UNITED STATES PATENT AND TRADEMARK OFFICE

Office Action Summary	Application No. 10/597,995	Applicant(s) VAN ESSEN, FRED	
	Examiner MOHAMMAD YUSUF	Art Unit 4177

DETAILED ACTION

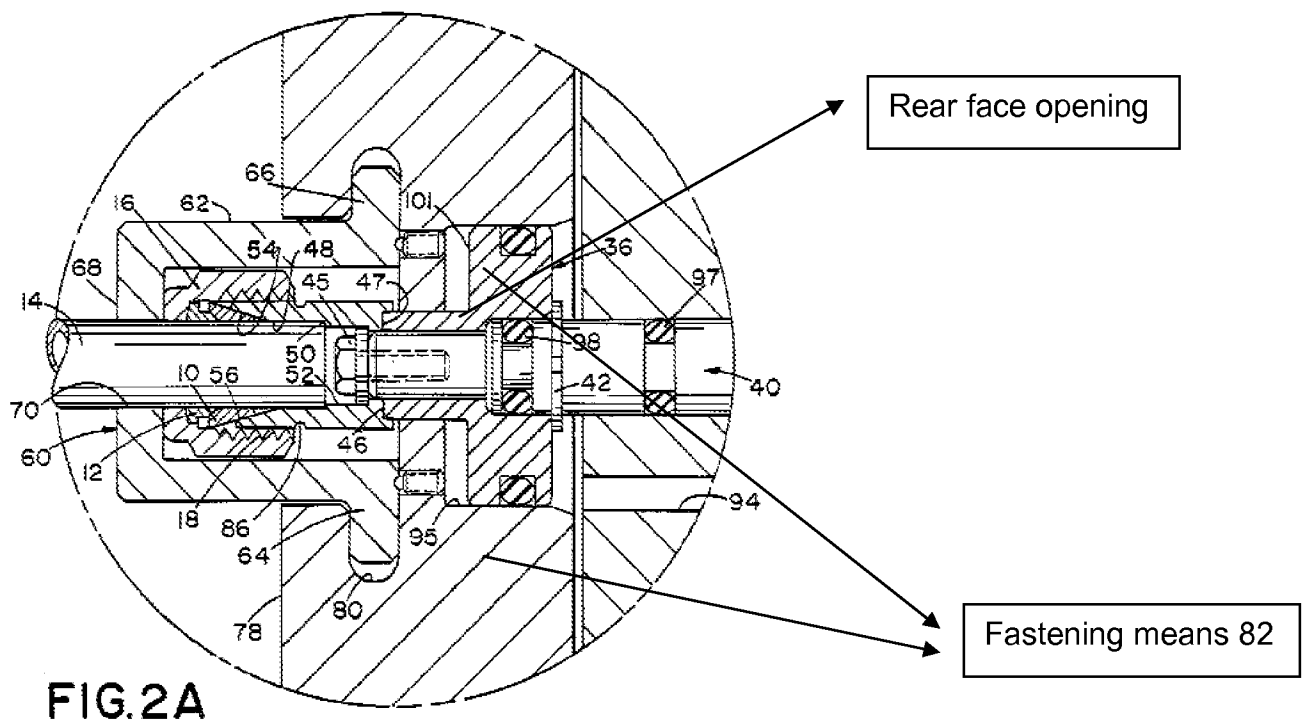
3. Claim 1 is rejected under 35 U.S.C. 102(b) as being anticipated by Johnston (US 4,873,755).

As to **claim 1**, Johnston teaches:

A head assembly (Fig. 2A) for a swage press (see title, "Swaging tool ...") including a housing (Fig. 2A, retaining cap 60) having a peripheral side wall (annular body portion 62), a front wall (second end 68) integrally formed with said peripheral side wall with an opening (aperture 70) in said front wall providing access to a press zone (press zone includes 16, 56, 45 etc in side the peripheral side wall or annular body portion 62) arranged within said peripheral side wall, said housing having an open rear face (shown on the attached Fig. 2A below);

a rear wall (78) secured by fastening means (fastening means 82) to said peripheral side wall (62) to at least partially close said rear face of the housing,

and a hydraulically operated (Fig. 2, hydraulic pump 90; also see column 6, lines 40-45) press mechanism (anvil 44) located within said housing (retaining cap 60) at least partially surrounding said press zone.

Johnston uses, (Fig. 2A, see attached figure above in paragraph 3), a sideways fastening means 82 instead of groove and wire mechanism as claimed. However,
